भारत सरकार - रेल मंत्रालय
अनुसंधान अभिकल्प और मानक संगठन
लखनऊ - 226011
Government of India - Ministry of Railways
Research, Designs & Standards
Organization, LUCKNOW - 226011

MODIFICATION SHEET NO. RDSO/2010/EL/MS/0393 (Rev.0), Dated 22.11.2010

Modification to address failures of Auxiliary converter cards.

Figure-2

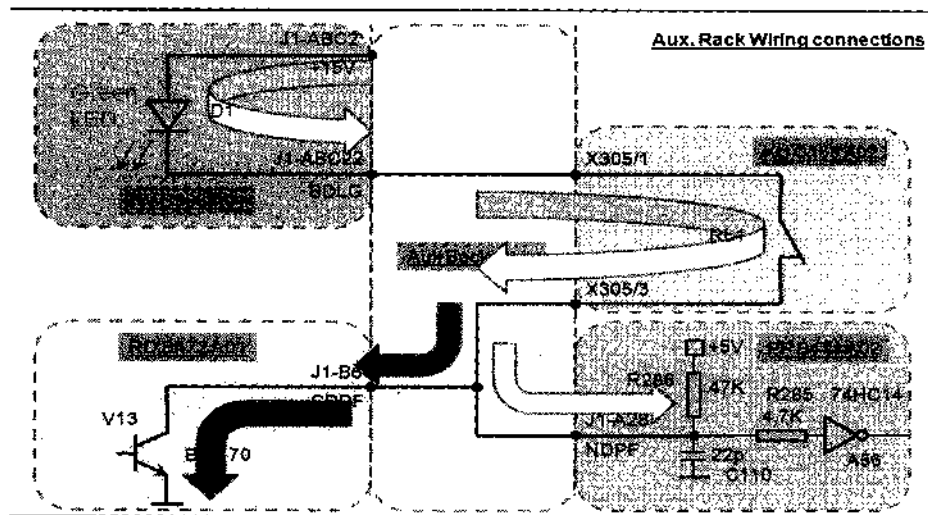
- 2.2 It has been reported by TOT partners that some of the failures occurs during functional testing also without any apparent reason.
- 2.3 On analysis of these failures it has been noticed that reversal of connector X305 in the back plane of KUC153 A01 card is leading to the wrong connections and consequently failures are taking place. This connector is no mechanically coded and has only two wire connections. When connector X305 is wrongly connected (connected upside down), the circuit formed is shown in figure 1. In this case +15 Volt supply connects via green LED on KVB993 card to relay RL1 on KUC153 card. The other end of this connects to the collector of transistor V13 on RDB 472. Sometimes transistor V13 gets turned on before relay RL1 is completely opened therefore leading to a short circuit of +15 V supply to ground for a short duration. As a result of this the voltage output of KUC153 may fall and this could lead to an interruption of the life sign from auxiliary converter rack to the VCU. This may also interpreted as a problem of "life sign missing" with KUC 153 card or PPB471 card. In some cases transistor V13 on RDB 472 also fails. The flow of current is shown in figure-2.

Figure-3

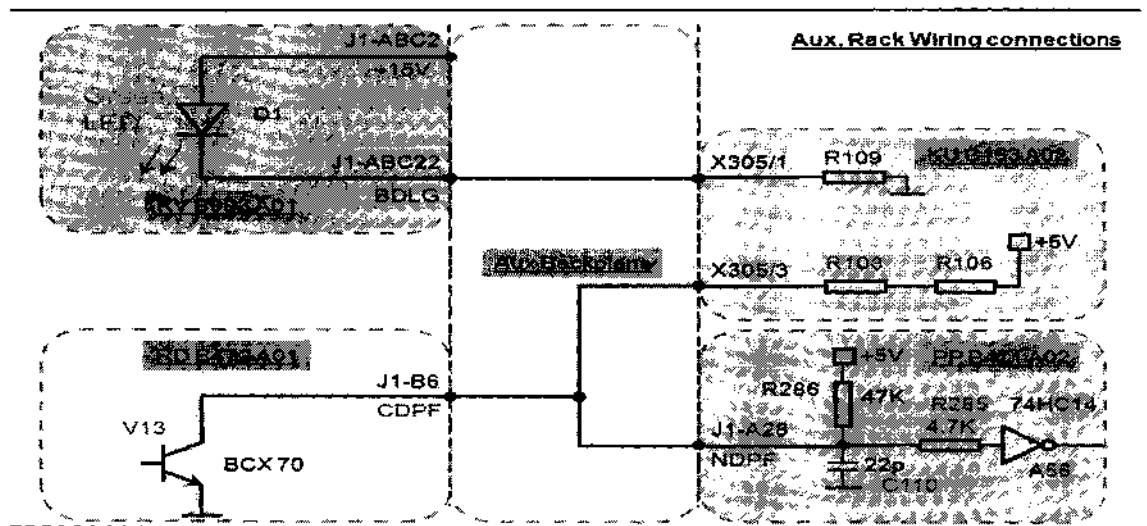
- 2.4 When the connector X305 is connected properly, the circuit is different and removes the connection of the relay from the circuit. The circuit in this case is described in figure-3.

Figure-5

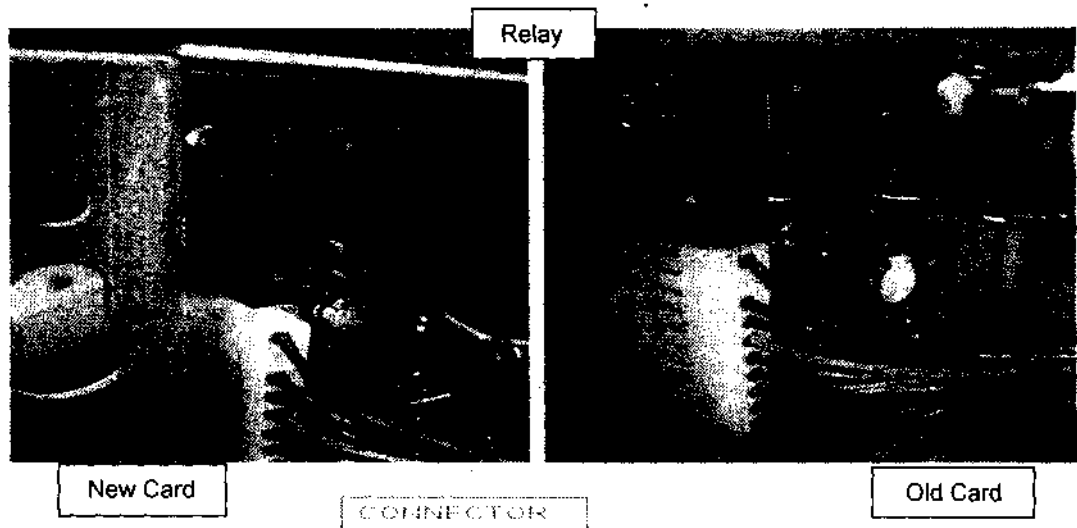
- Step-2:** (i) Observe the connector shown in picture-2 w.r.t. black and green cable.
- (ii) If the position of connector (j3) matches with the position as shown in picture-2 (observe connector cables black and green are close to relay) then the connector has to reverse.
- (iii) Also in Old type PCB cards, a colour coding was done which is shown in picture-6 below. The correctness of connector can be checked with colour code also.

Figure-6

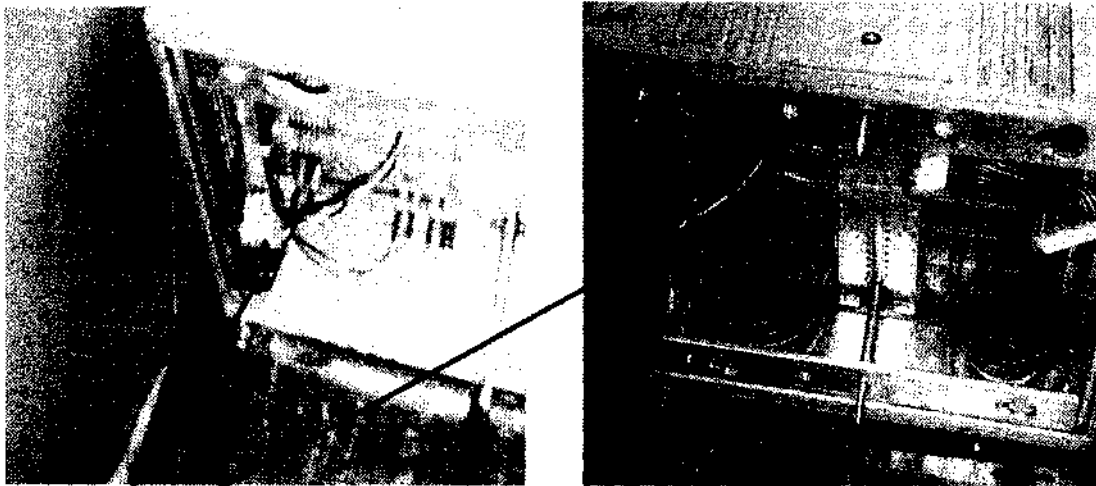
- 2.5 In older cards, a blue colour marking was done on connector X305 to avoid wrong connection which is shown in figure-6.
